UCCO/Lick APF

IceStorm Enclosure (Series 2)

Lick APF Site Inspection Report

6 June 2007

Figure 3.1.3 Hatch struts.

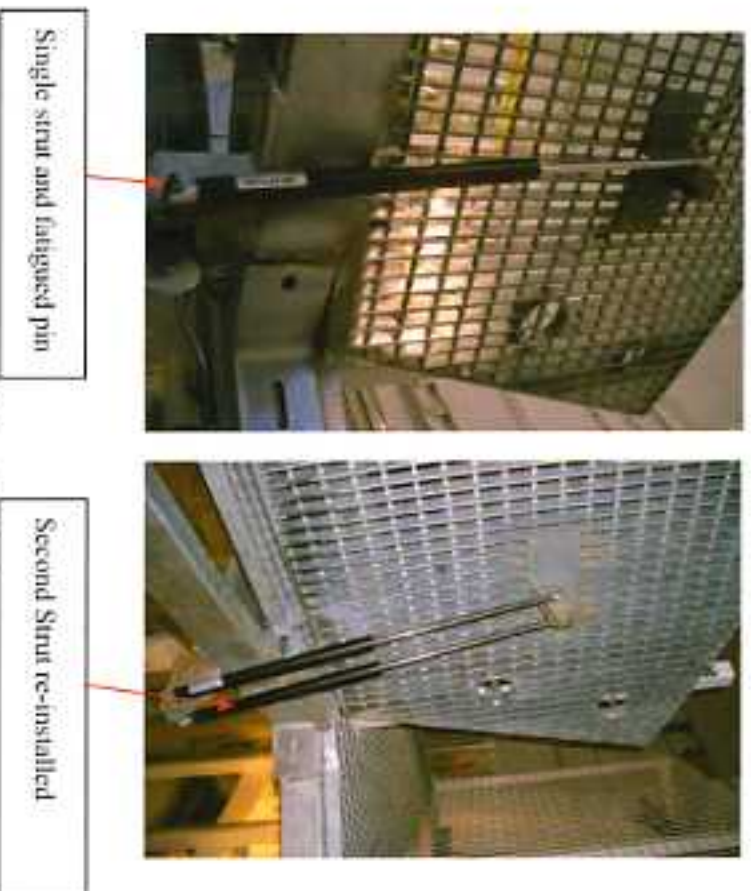
UCCO-Lick indicated that the level 3 floor hatch mounts are not adequate and safe. An attempt was made by EOS to improve the use of the hatch by removing a gas strut from each hatch section during 2006.

It is agreed this is not an adequate fix and potential for serious injury increased, due to insufficient force applied by the single strut preventing the hatch from falling. It has also meant that strut pins may have fatigued as they are "working" twice as hard.

A site inspection prompted Jason Chapman to advise UCCO-Lick to lock the hatches in a safe position until appropriate remedy is applied. The second gas strut was re-installed to the heaviest hatch piece and the hatch became workable.

The position of the struts is determined by the geometry of the hatch.

Figure 5 Excerpt from door drawing – Calls out dead bolt as “Door Hurricane Bolt”

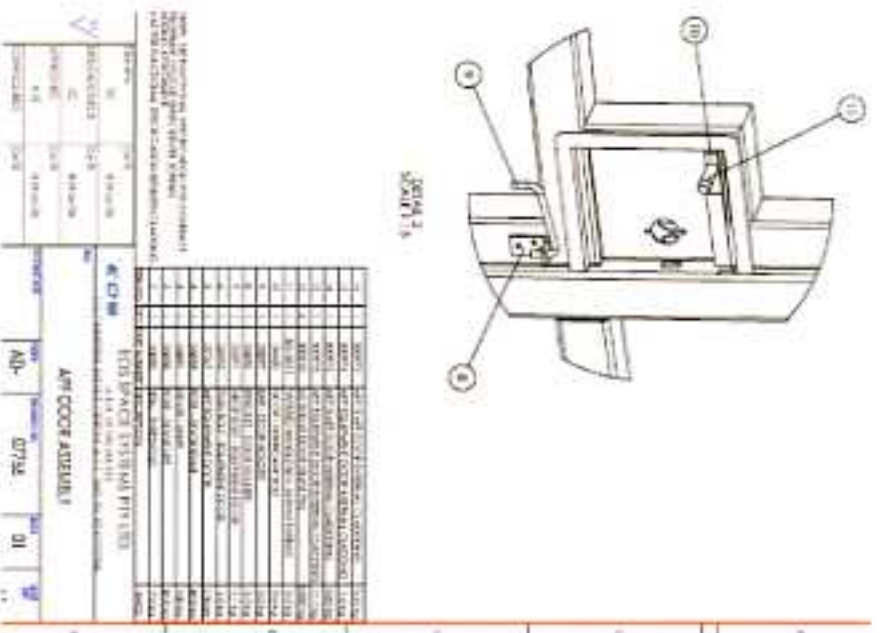
UCCO-Lick claimed a safety hazard was imposed by the exterior deadbolt system on the staff entry door. The claim was made that someone could be trapped inside the enclosure if the bolt was utilised. UCCO-Lick appeared to be under the impression the deadbolt was temporary.

The deadbolt existed as a precautionary lock during extreme survival conditions, to avoid the door latch being the only part preventing the shaft door from being sucked open. The deadbolt has always been part of an IceStorm design, it is present at the Mt Stromlo facility and appeared on design review models.

EOS does not consider this as a design flaw or safety risk and proposes no further action is required. However, for the abundance of caution, if UCO-Lick deem this to be an unacceptable risk, then we propose to cut off the deadbolt tang to render the deadbolt inoperable.

Figure 7 Longitudinal seal blade tape, preventing seal flap snags on blade ends.

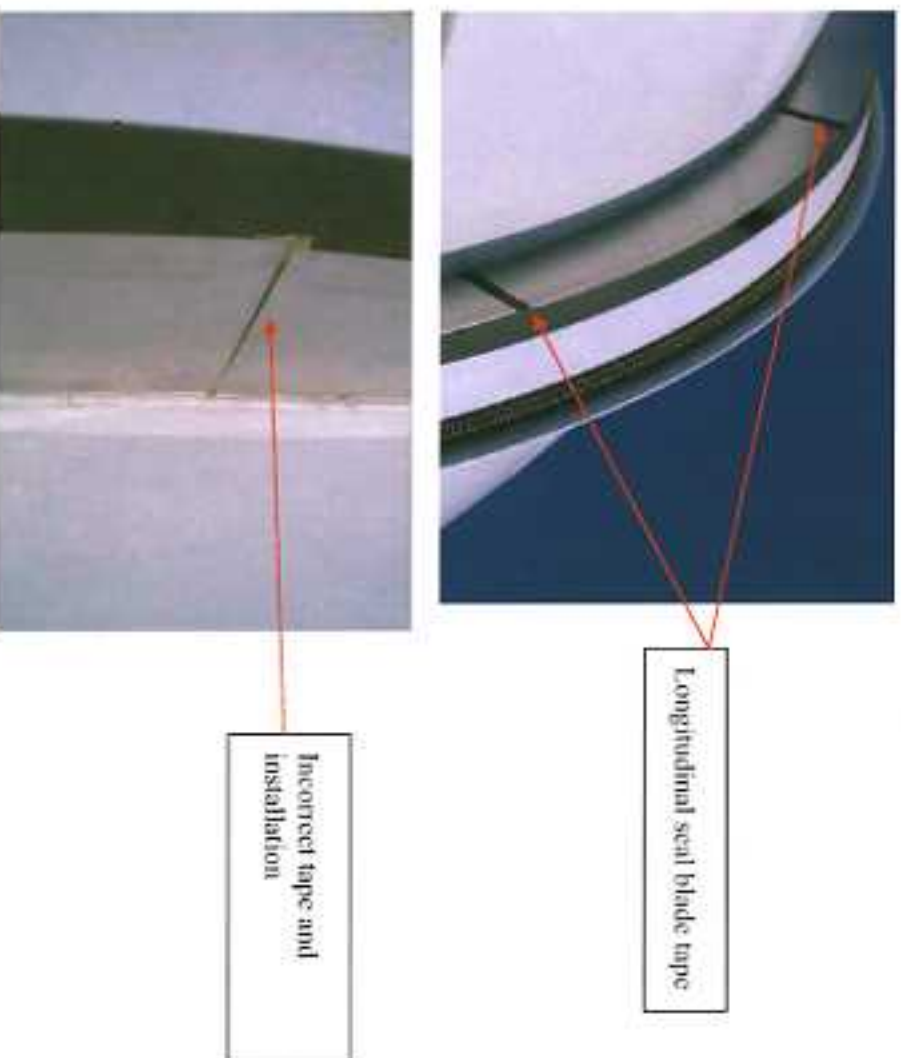
UCCO noted that a tape installed on the longitudinal seal blade was falling away.

Further investigation by Jason Chapman and Matt Radovan showed the tape on the seal blade was not the correct tape specified by EOS. It was also noted that it was installed in incorrect positions and was probably installed on stainless steel blades that were not cleaned sufficiently prior to installation of the tape.

Temporary tape had been installed during shutter frame alignment. The final to-be-installed tape was issued and was to be re-installed by W/PY after shutter alignment work was complete.

New tape will have to be installed after the trough re-caulking procedure has been completed. When re-installing the seal blades, they will be required to properly install the correct tape. EOS can provide instruction on this.

Figure 8 Longitudinal seal flaps.

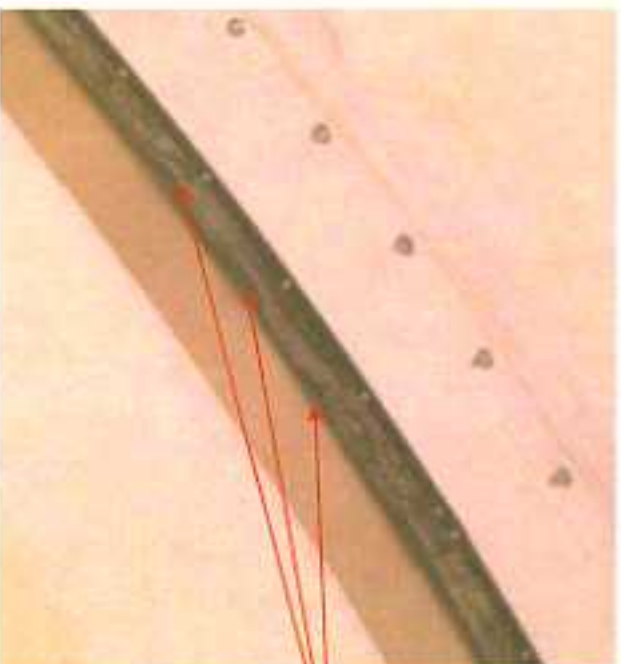
LICO-Lick has stated that the shutter longitudinal seals flaps are not sealing appropriately due to wrinkling.

Wavy / wrinkled longitudinal seal flaps. There is a potential to cut and tape to reduce the wrinkling effect.

These longitudinal seal flaps are installed to prevent significant light leaks and to minimize air flow between the exterior atmosphere and the enclosure interior. No light leaks were observable along these seal flaps. It is not easily determined if the seal flaps would improve air leakage significantly if they had 100% contact along their length.

As no moisture is infiltrating at these points EOS has determined the seal positions and function as acceptable, and replacement of the seals is not necessary.

At UCO-Lick's discretion, the seal flaps may be relieved to reduce wrinkling, with cutting then taping (with UHMWPE tape) between joints by UCO or WPY during the re-caulking project.

Figure 9. Air gap present in pier seal.

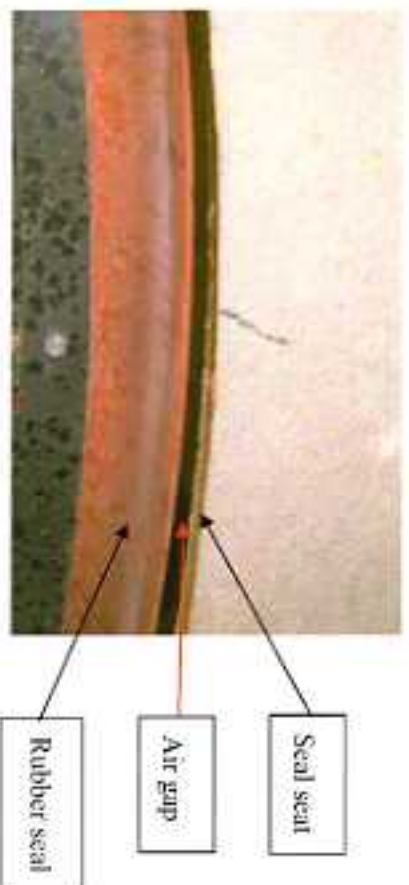
UCO-Lick observed a source of light leak from Level 1 to Level 2 during night hours, when Level 1 lights are switched on and the observing space is in darkness. The leak was traced to the seal that runs around the telescope base.

It appeared that there is a significant gap were the silicone rubber seal flap should run on a stainless steel pier seal seat.

The problem appears to stem from straight strips of rubber being bent on a tight radius to form the seal flap. The radius is seemingly too tight and the rubber folds back on itself without touching the seal seat.

EOS will test some different rubber configurations to find the pattern that works best. Our rubber could be sent to UCO-Lick to install and alleviate the problem.

Figure 11 Different cladding on the entrance door and ring wall.

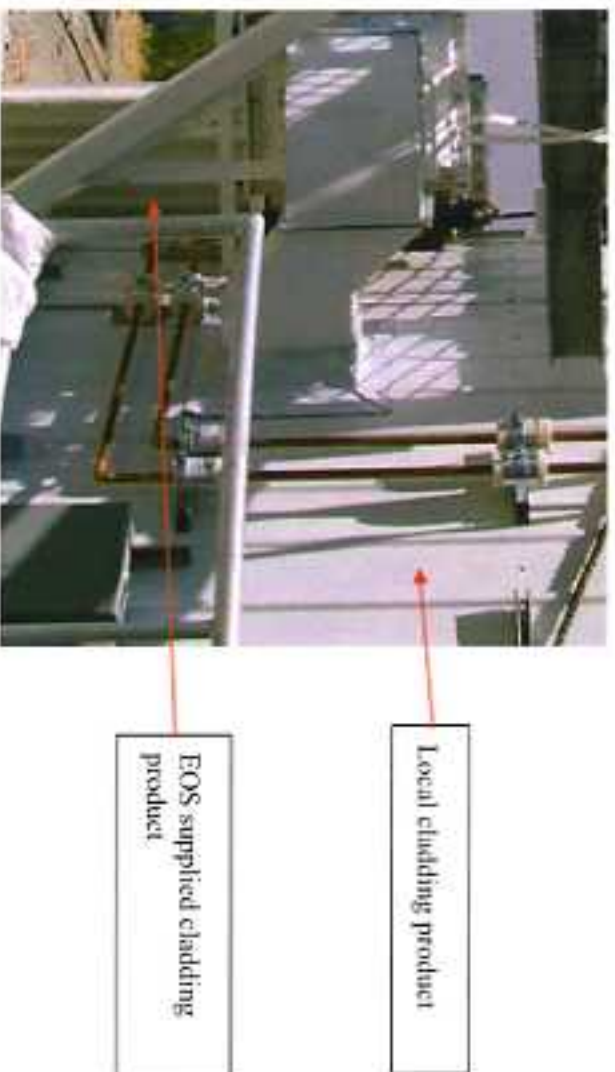
UCCO-Lick noted that during the assembly there were problems with steel ring wall cladding supply. Locally sourced cladding was required to finish the enclosure.

The EOS supplied cladding profile differed to the locally sourced cladding profile, although the colour is a close match. When the ring wall was clad, the entry doors were left the same as they were fabricated with correctly installed cladding.

EOS does not consider the cladding profile difference to be a function, design or other issue and in fact enhances safety as it acts as a tactile indicator of reaching the door when highs are extinguished in the enclosure.

The cladding on the door has been sealed with closed cell foam that conforms to the EOS supplied cladding profile. The advantages of keeping the supplied cladding profile outweigh any visual effect from replacing it.

Figure 13 Shutter rail - Shutter flares installed to these

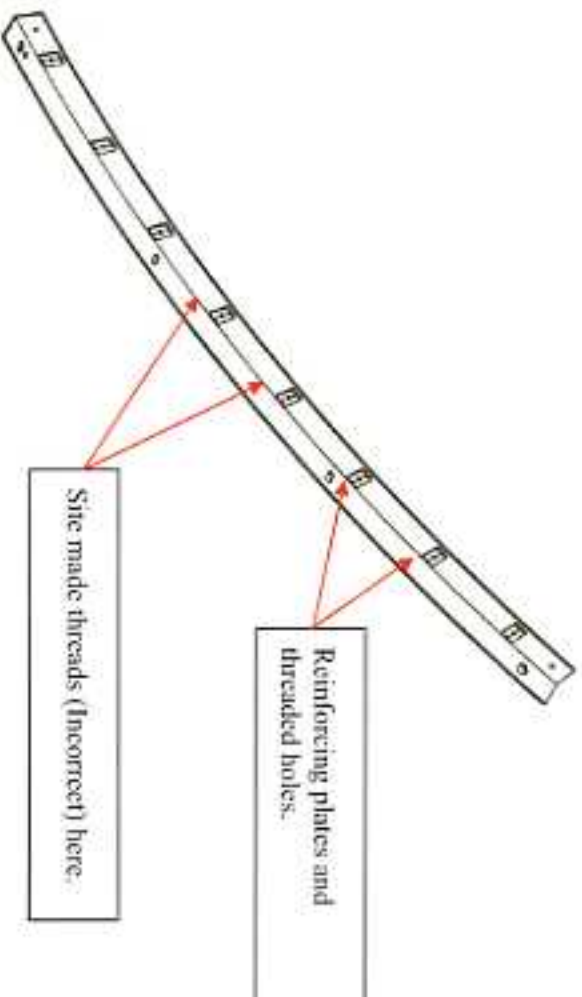
UCO-Lick raised an incorrect fit of shutter flares to Jason Chapman. Several of the (cosmetic) flares, which are attached to aluminium rails by screws, appear to missed the intended threaded hole and backing plate, and were screwed directly to un-reinforced aluminium rails.

UCCO-Lick would like assurances that the incorrect installation still meets survival conditions.

EOS will calculate the effect of the as built installation and email our findings to UCCO. If the flares do not meet specification, rectification will require holes in the flares to be re-drilled and fasteners installed to the correct threaded holes. Old holes can be plugged (white plastic plugs) closed. As the flares are cosmetic covers for drive gear, the standard of weather sealing does not matter.

Any rectification must be completed when a boom lift (Elevated work platform) is on site. It would be ideal to do this during the re-calk exercise. Calculations will be made as soon as possible.

Figure 14 General example of trough sealing quality

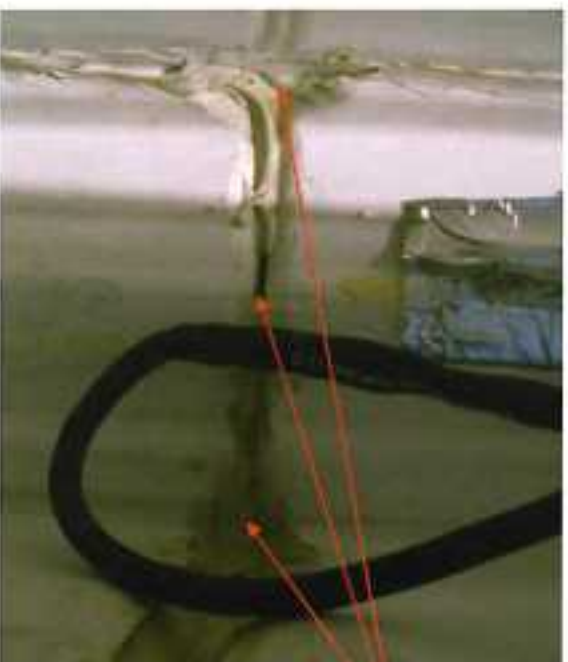
UCCO-Lick has indicated water ingress coming from the region of the shutter chain troughs. Claims had been made by UCCO-Lick and WPY that the design of the troughs was such that sealing was impossible due to large gaps between troughs.

Upon inspection by Jason Chapman and Matt Radovan (with Steve Vogel in attendance), it was determined that the joins were in fact sealable, or within acceptable tolerance ranges allowing sealing to occur, but the caulking by WPY contractors was poor.

Large pockets and gaps were easily distinguishable in most of the joints reviewed. All of these flaws would cause serious leaks, especially as the troughs act as a gutter during periods of precipitation. High flows of water would be prevalent in these areas.

Gap through to enclosure interior, general poor quality caulk attempt in the trough region

EOS will provide a procedure to re-caulk the enclosure infills and troughs, which will attempt to eliminate the need to remove the shutters from the enclosure.

Figure 16 Shutter boot leak

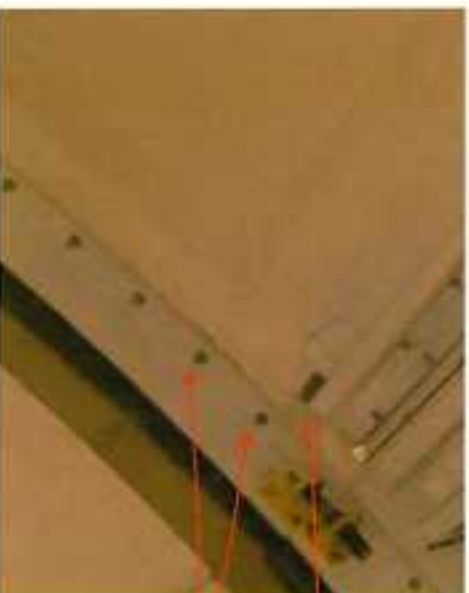
UCCO-Lick found water dripping from 2 bolts on the upper right hand side of the front shutter, after a period of rain. An *assumption* was made that water had made its way into the enclosure via flare attachment points.

After investigation and suggestions by Jason to pour water on the shutter transverse gutter, the leak point was identified as a hole in the caulking, under the upper right hand side of the top transverse beam. Water channelled between an interior seal, until it reached the through-bolt connections and ran into the enclosure.

EOS suggests that UCCO or WPPY staff fill the hole with caulk during the shutter trough re-caulk project.

Figure 17 Shutter butt joint light leak

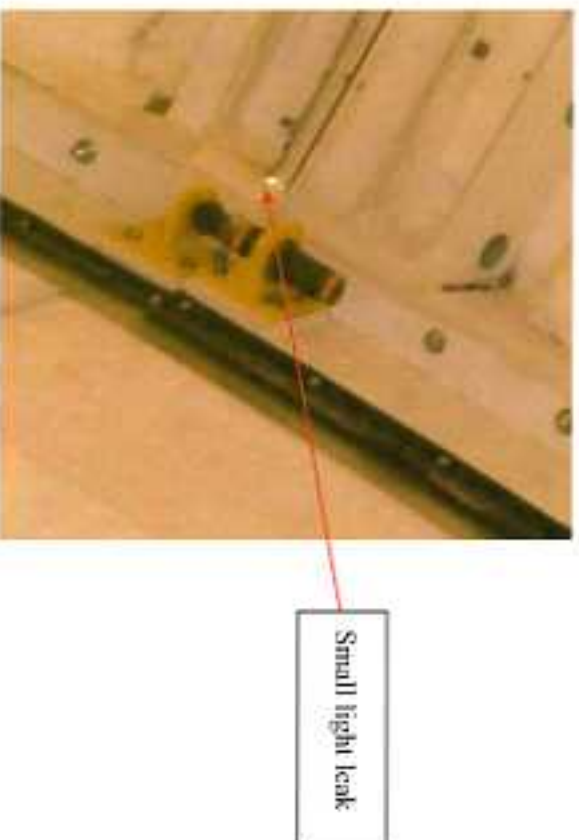
UCCO-Lick identified a light leak, but no mention was made of a water leak at this point.

UCCO-Lick staff (Matt Radovan) could not put his finger through the hole from the enclosure exterior, due to the geometry of the shutter fiberglass and frame.

For water to ingress at this point, it would have to travel through a series of fiberglass overhangs, and be blown up-hill.

Leak originated outside around here

Leaks entered dome here

EOS response is that this claimed leak is not in fact an issue, as no evidence of water, or the ability for water to enter here exists. UCCO-Lick can adapt the shutter if they wish to try and reduce the small amount of light leakage.
